UNITED STATES  
ATOMIC ENERGY COMMISSION  
WASHINGTON 25, D. C.

This refers to your letter dated May 31, 1953, requesting amendment to Special Nuclear Material License No. SNM-348, for Harry Diamond Laboratories.

SUBJECT: Amendment to Special Nuclear Material License No. SNM-348

Figure 4

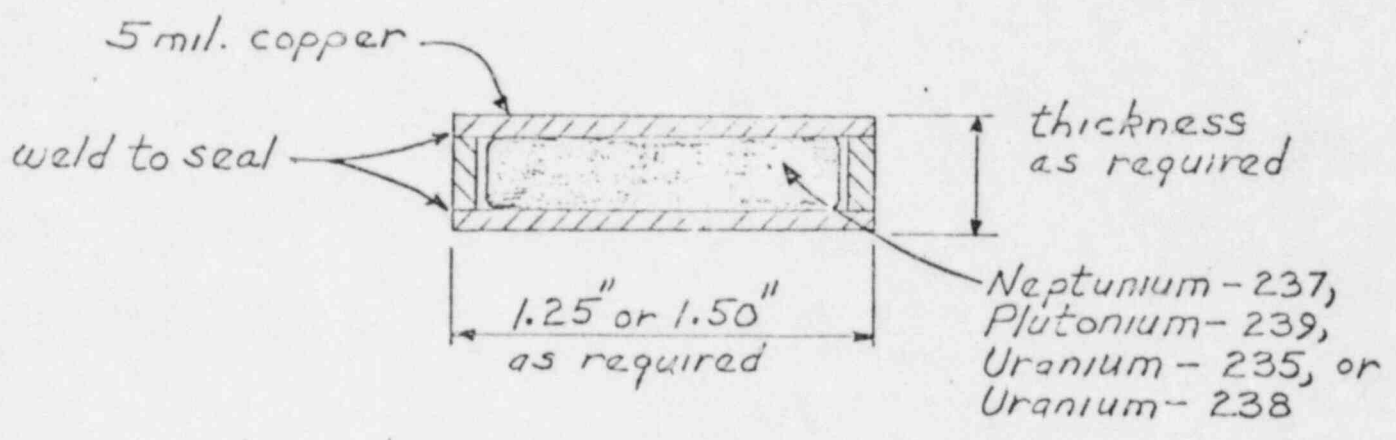
1. A more detailed description of the physical characteristics of these foils including a drawing showing the solder seal and an evaluation of the structural integrity of the seal.
2. The maximum integrated neutron dose to which the foils will be exposed and the maximum radiation intensity (mr/hr) that is expected on the foils.
3. Description of your procedures for removing the irradiated foils from the reactor including survey equipment (type and range) and handling tools.
4. Description of the analytical procedures and equipment involved in handling the irradiated foils including transfer containers and handling tools.
5. Description of the storage area where highly activated foils will be stored for decay.
